AUTOMATIC TRANSMISSION SERVICE GROUP

REVISED EDITION

Since the introduction of the THM 440-T4 Transaxle in April, 1984, there have been many major engineering design changes. These changes have affected nearly every part used in the THM 440-T4. This Update Handbook will explain each change, the parts affected by the change, and any parts interchangeability problems created by the change.

Figure 36

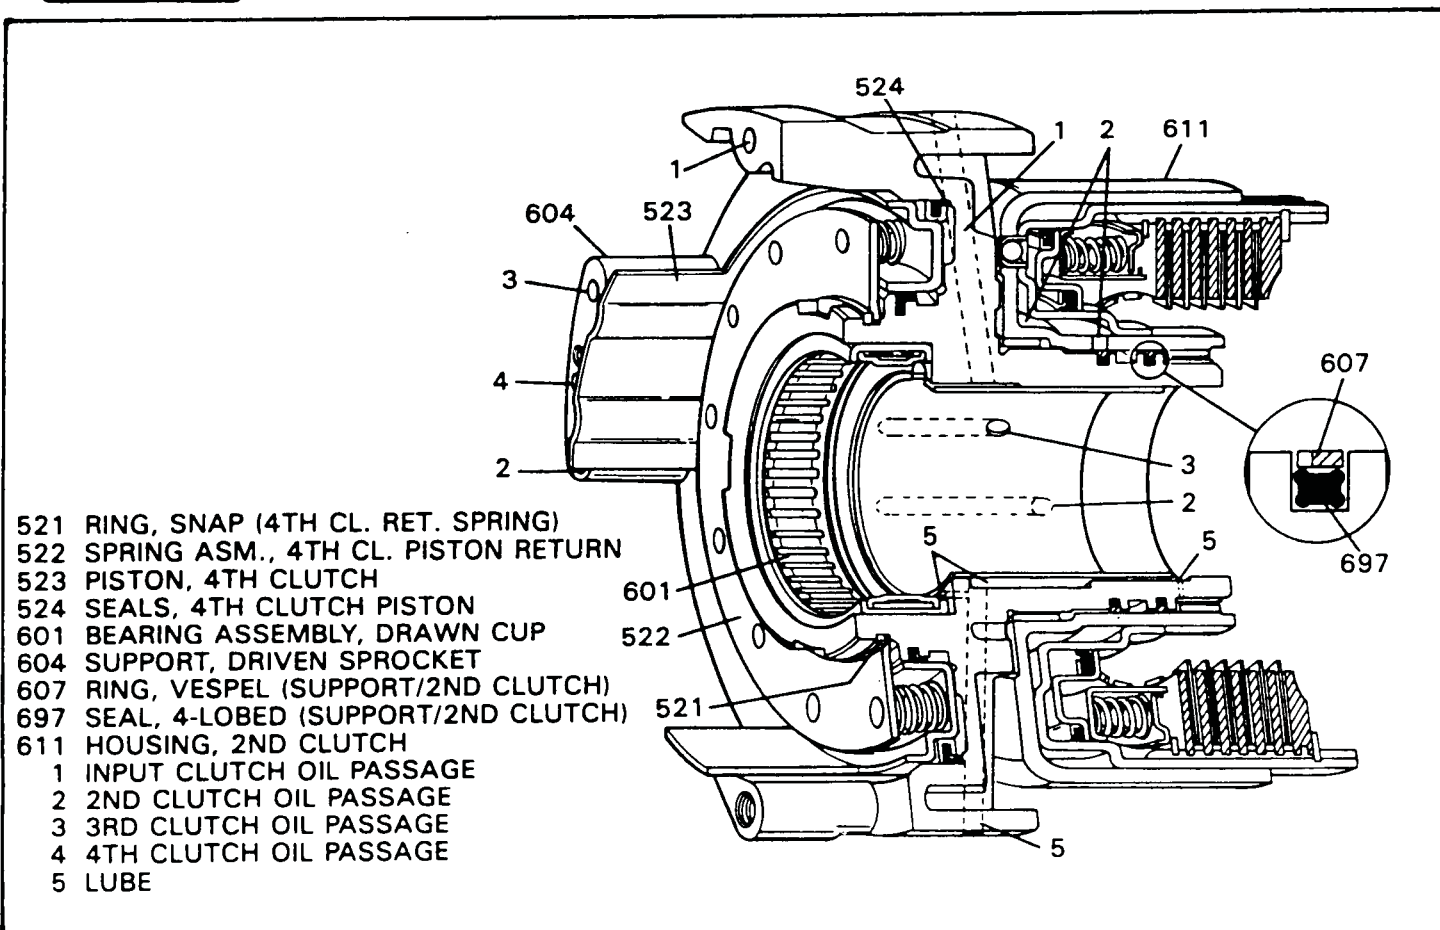
Change: "Vespel" Sealing Rings and 4 Lobe Ring (See Figure 36).

This change, also initiated in the 1987 models, related to 2nd clutch durability and was on the driven sprocket support. The 84-86 models have large steel, hook joint, sealing rings to feed the 2nd clutch. In 1987 models the steel rings were replaced with "Vespel" (Plastic), step joint, sealing rings, that have tabs on them to prevent them from spinning in the driven sprocket support (See Figure 37). This made it necessary to machine slots in the driven sprocket support, to accept the tabs on the "Vespel" rings. There is also a special 4 lobe ring that goes in the ring groove under the "Vespel" ring, and acts as an expander for the "Vespel" sealing rings (See Figure 36).

- 1) Driven Sprocket Support - Slots added to accept tabs on the "Vespel" sealing rings, and ring grooves machined deeper to make room for the 4 lobe ring (Expander).
- 2) No. (697) 4 lobe ring acts as expander for (607) "Vespel" sealing ring (See Inset, Figure 36).

Reason: The second design sealing rings provide a much better seal for 2nd clutch oil, and thus improved durability.

Figure 42

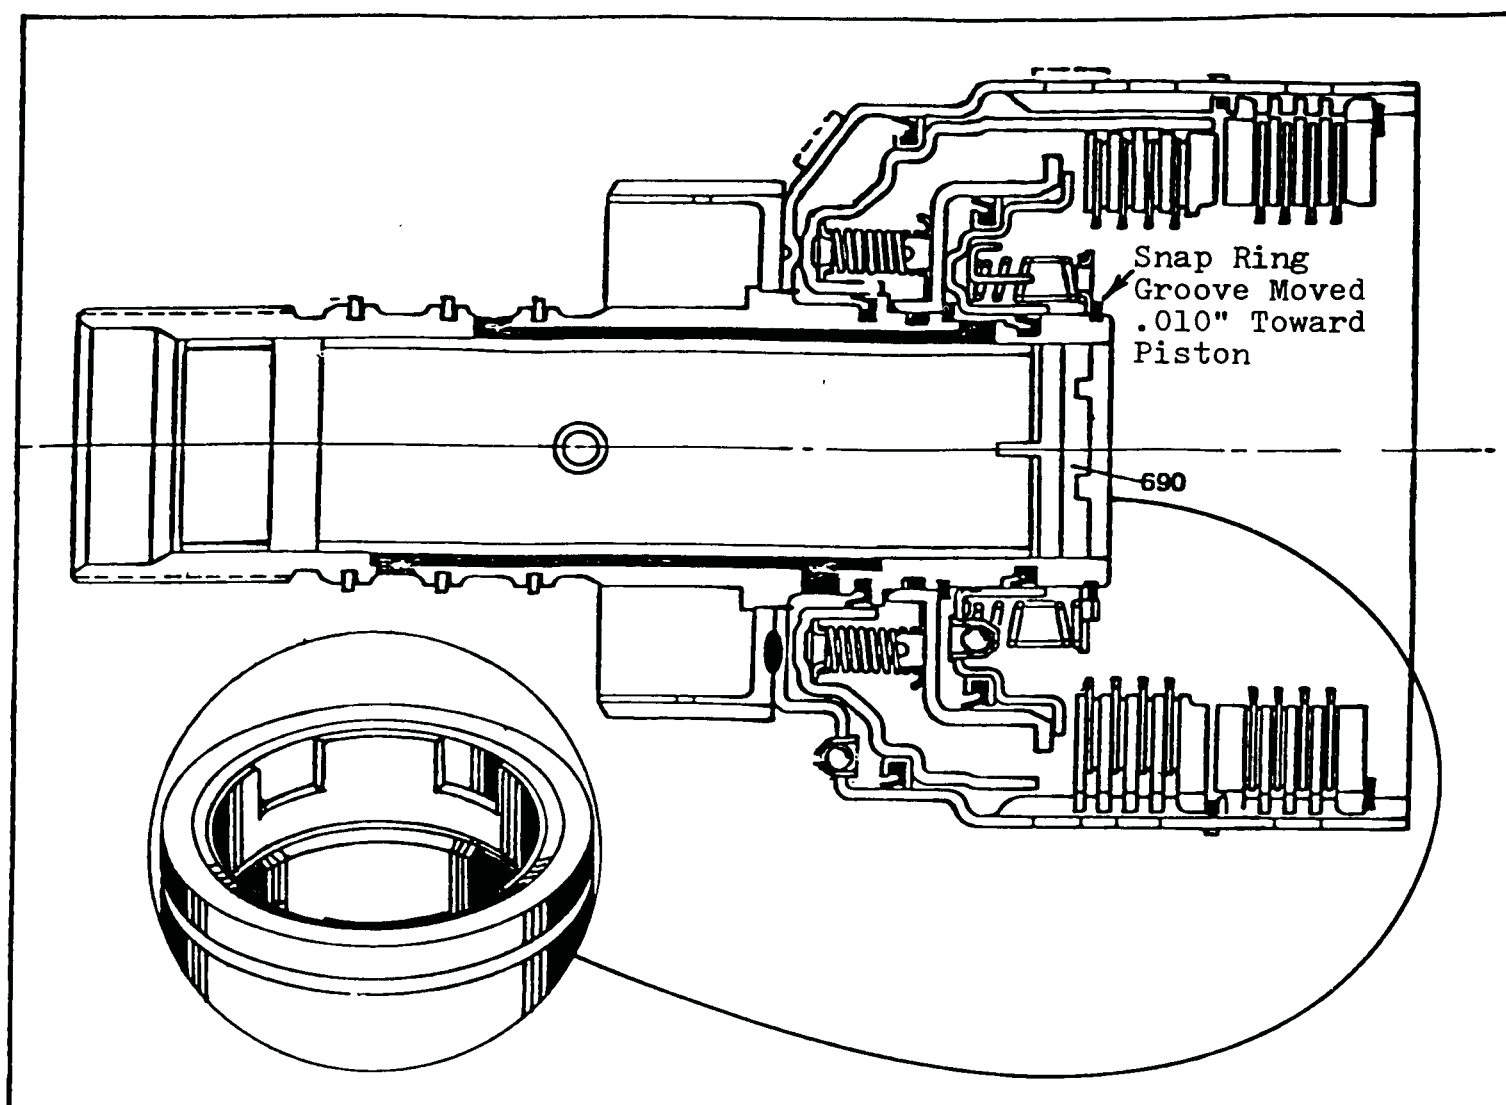
- 1) 3rd Roller Clutch, Outer Race - Modified to accept the added oil dam.
- 2) 3rd Clutch Return Spring Assembly - Tabs removed from top of return spring assembly, because of interference with added oil dam (See Figure 41).
- 3) Input Housing - Snap ring groove moved .010" toward the 3rd clutch piston. This was done to move the 3rd clutch return spring assembly an additional .010" away from added oil dam for added clearance (See Figure 42).

NOTE: If new input housing is purchased, be sure to remove (690) sleeve from old input housing and reinstall in the new input housing, as it does not come with the new input housing (See Inset, Figure 42).

This (690) sleeve has notches in it to accept the tangs of the "Top Hat" washer to prevent the washer from spinning in the housing (See Inset, Figure 42).

Figure 46

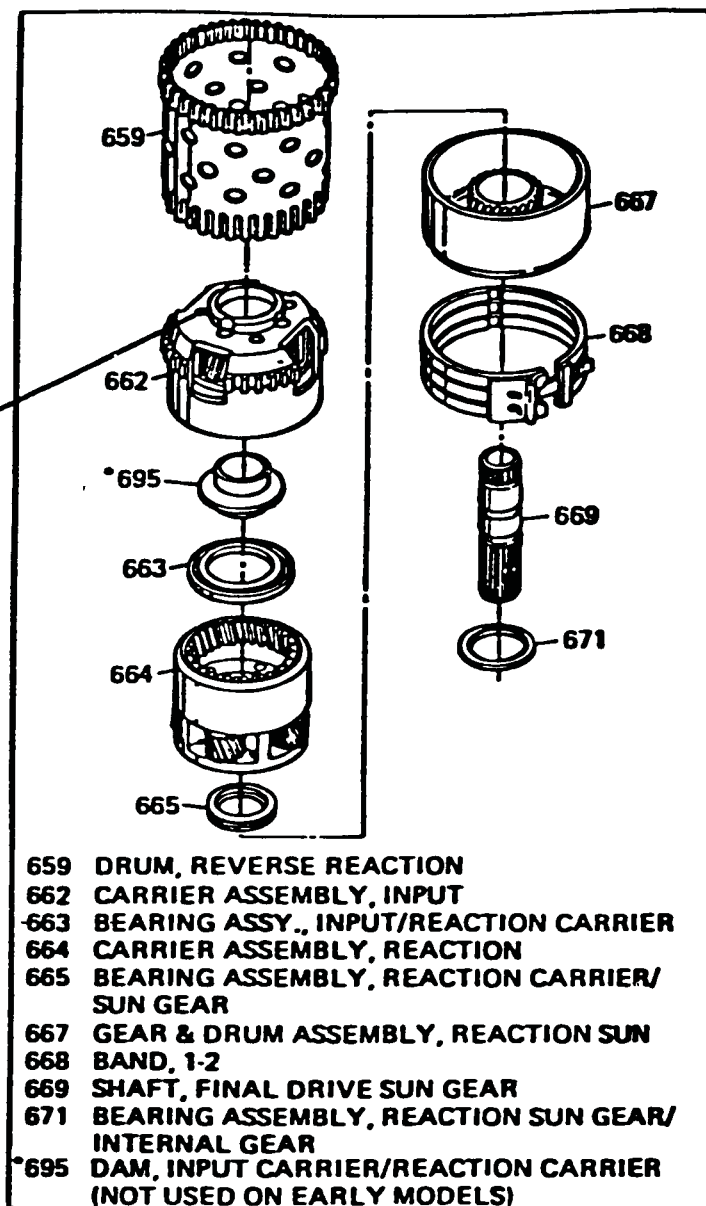
- 1) Input Sprag Assy(653) - Length of sprags increased by .095" and redimensioned end plates.
- 2) Outer Race(654) - Wider by .050".
- 3) Inner Race(650) - Wider by .142".
- 4) Retainer(655) - Shallower by .065" (See Figure 49).
- 5) Spacer(657) - Thinner by .142" (See Figure 49).
- 6) Input Carrier(622) - Shoulder machined down to shorter dimension (See Figure 46).

CAUTION: The input carrier must be replaced or modified as per specifications in Figure 46. If not replaced or modified, an interference will result and damage to the transaxle. The lip protruding on top of the input carrier must be machined to meet the dimension shown in Figure 46. Extra care must be used in the machining process, as the torrington bearing will not come out of the input carrier.

Figure 49

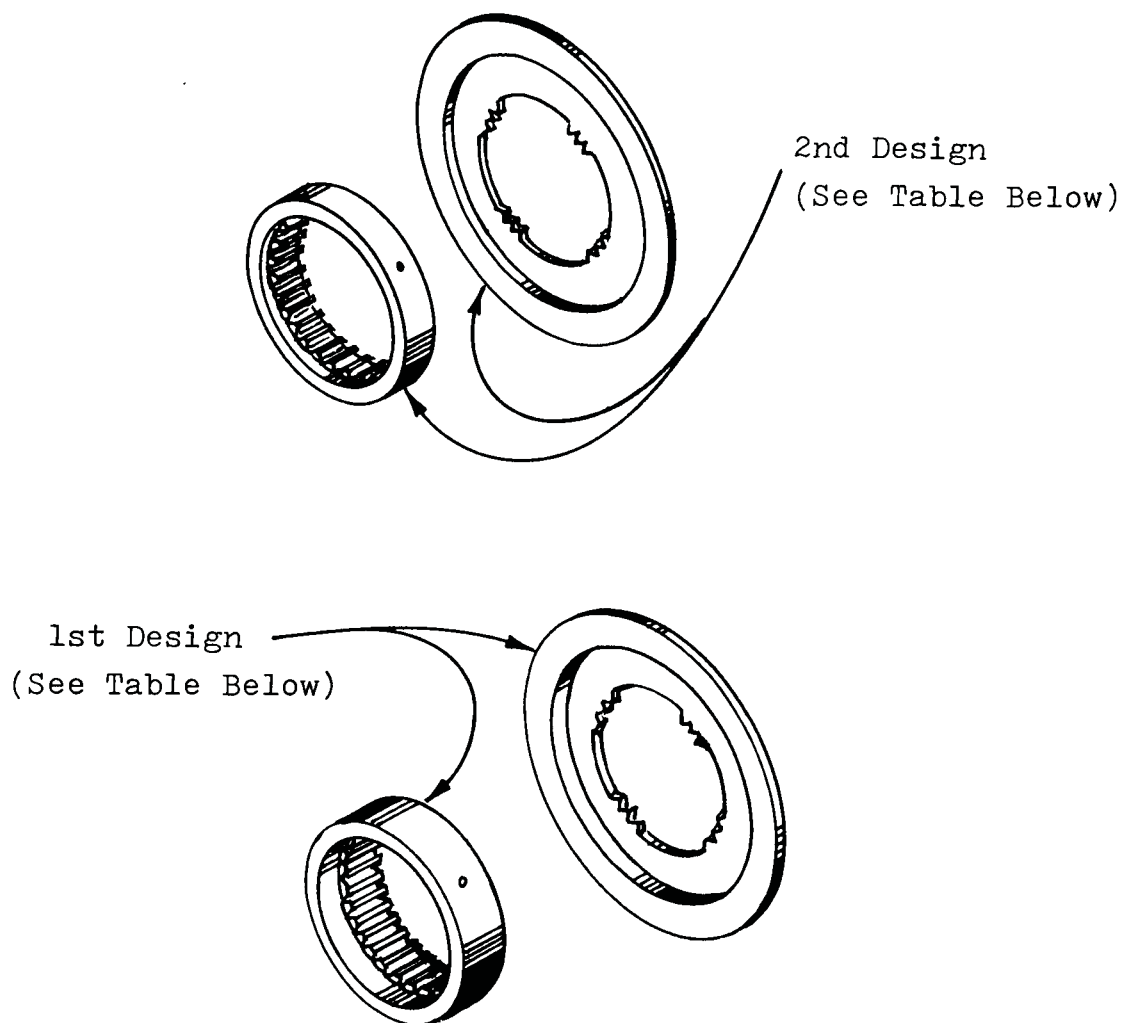
EARLY	LATE
Individual Sprags(653)	.095" Wider	.305"	.400"
Outer Race(654)	.050" Wider	.964"	1.014"
Inner Race(650)	.142" Wider	.790"	.932"
Retainer(655)	.065" Shallower	.140"	.075"
Spacer(657)	.142" Thinner	.495"	.353"

Figure 51

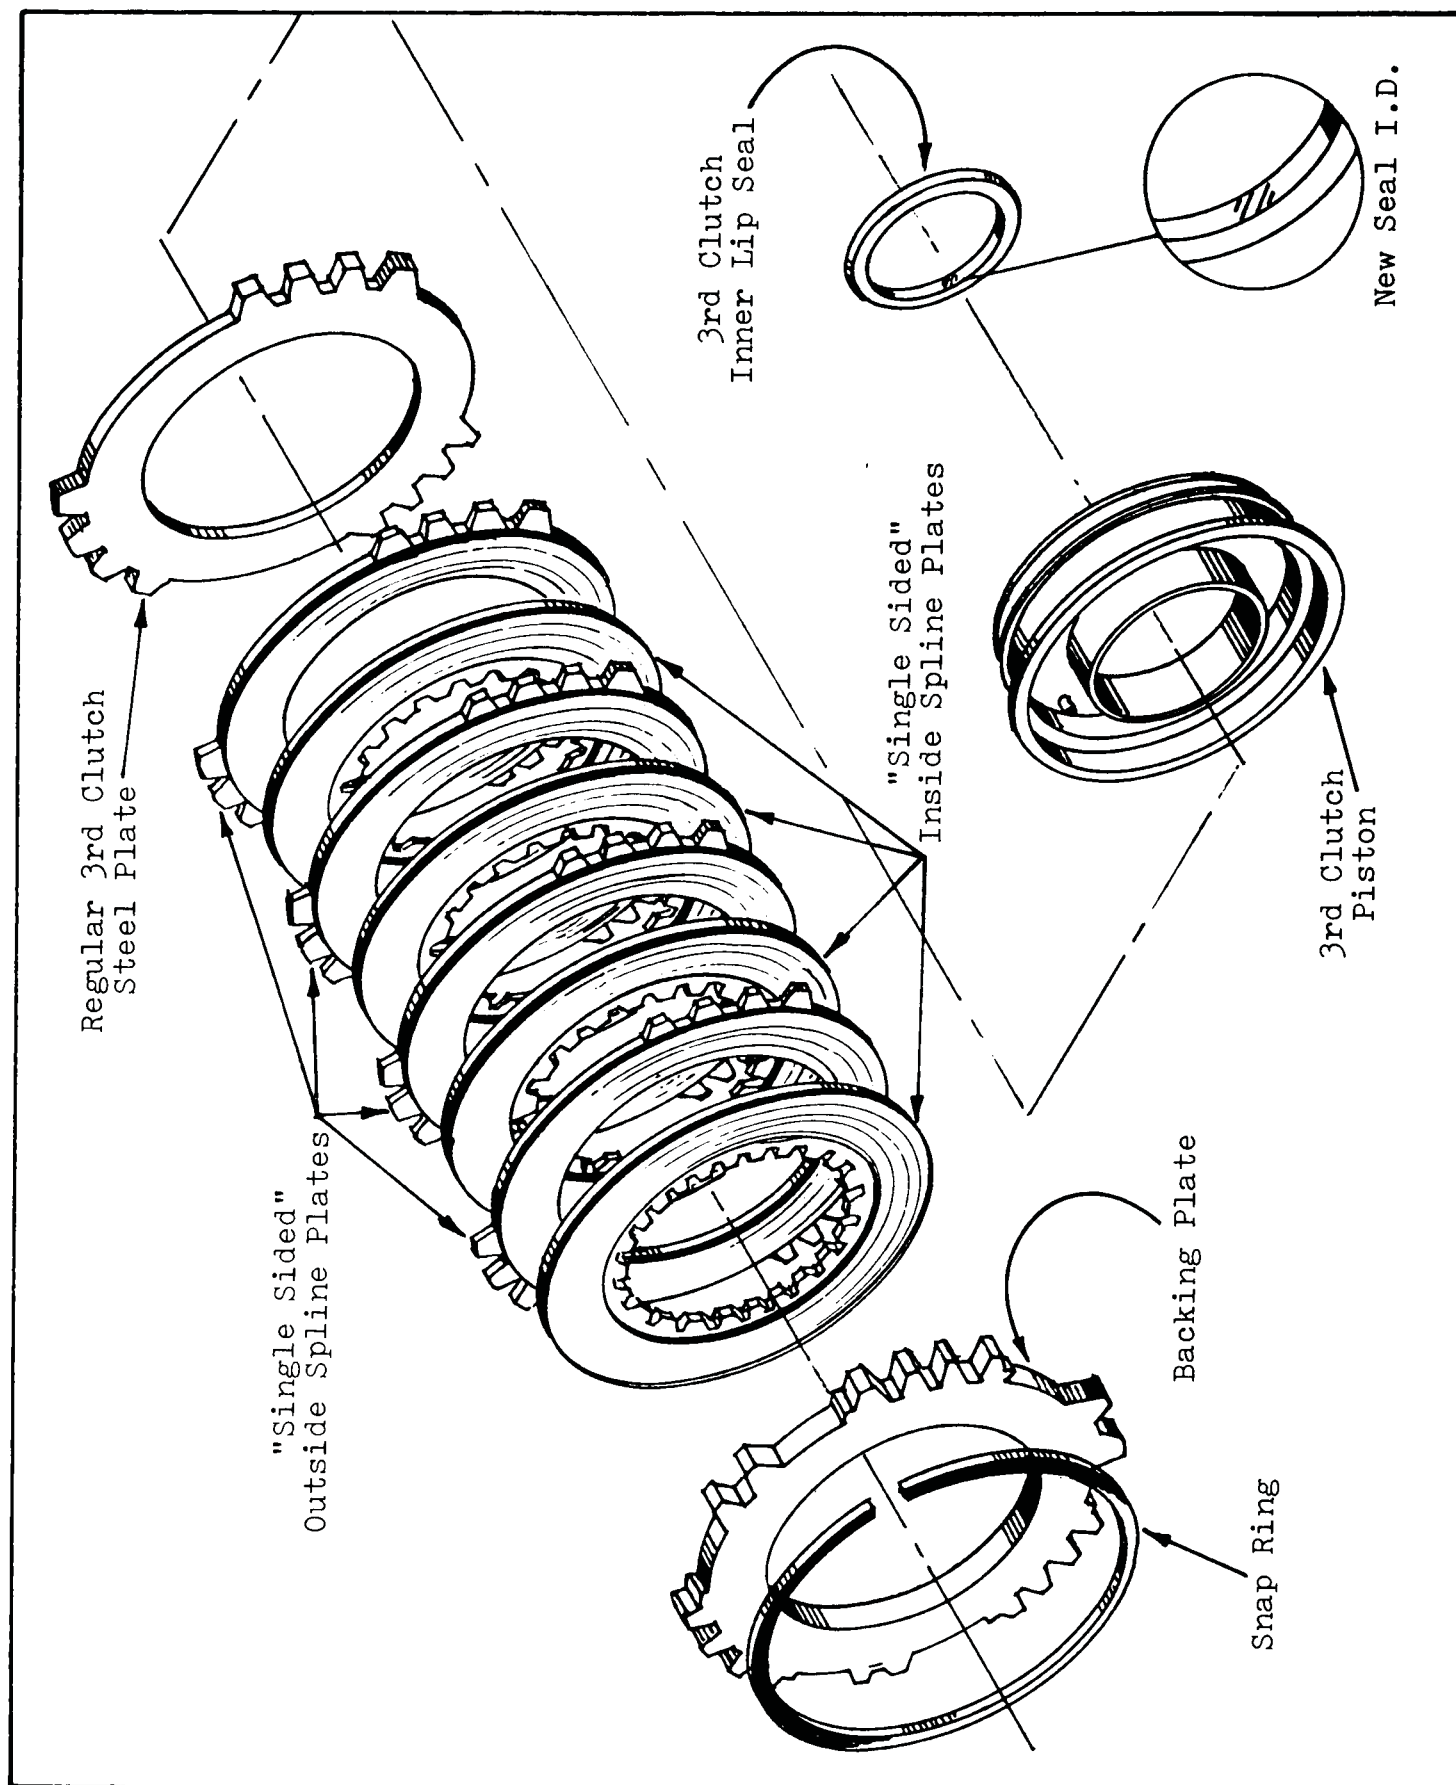
1st Change: Single Sided 3rd Clutch Plates - Lining on one side only both inside and outside spline plates (See Figure 51).

Will retro fit backwards, and is recommended. New OEM Part No. is 8662673 on the new 3rd clutch lip seal. For positive identification of the new seal, check for hash marks on inside diameter of lip seal (See Inset, Figure 51). For difference in profile compare Inset "A" and "B" in Figure 52.

Figure 52

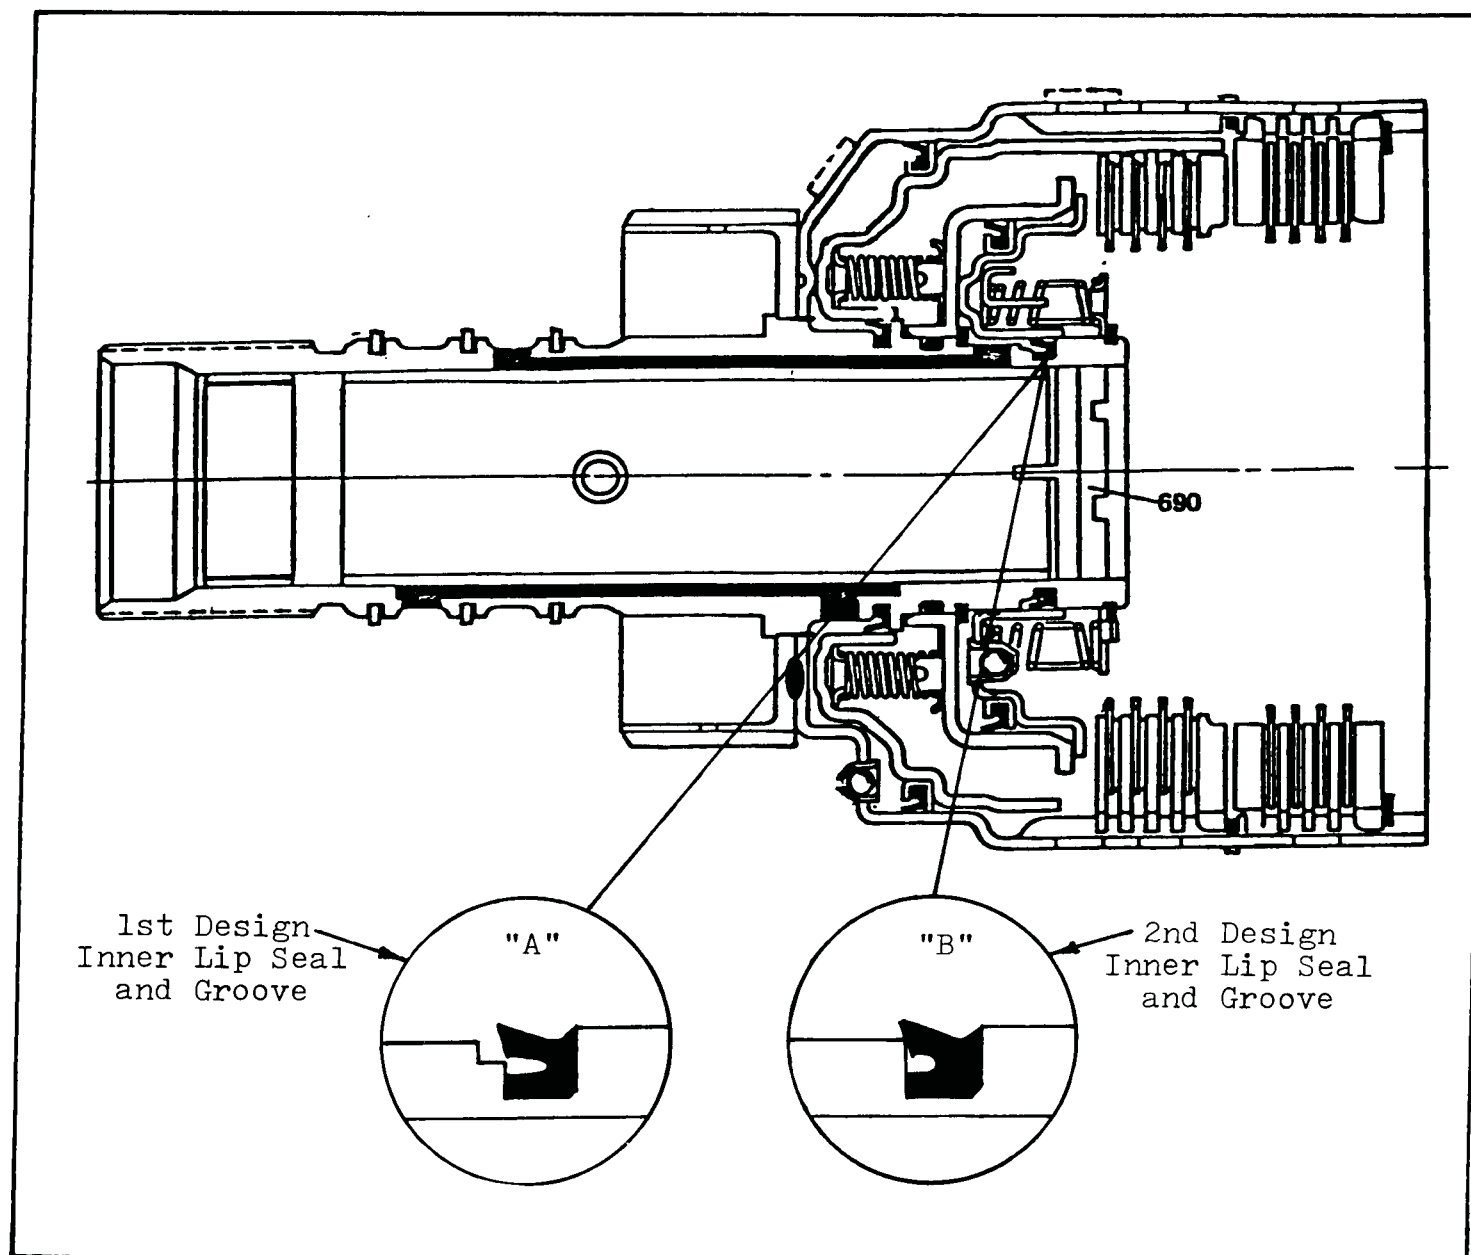
- 1) 3rd Clutch Inner Lip Seal - Thicker profile to help prevent seal from rolling (See Inset, Figure 52).

3rd Change: Input/3rd Clutch Housing - Revised 3rd Clutch Inner Lip Seal Groove (See Figure 52)

- 1) Input/3rd Clutch Housing - One machining process eliminated in groove for the 3rd clutch inner lip seal, which provided more support for the lip seal to prevent it from rolling.
(Compare Inset "A" and "B", Figure 52).
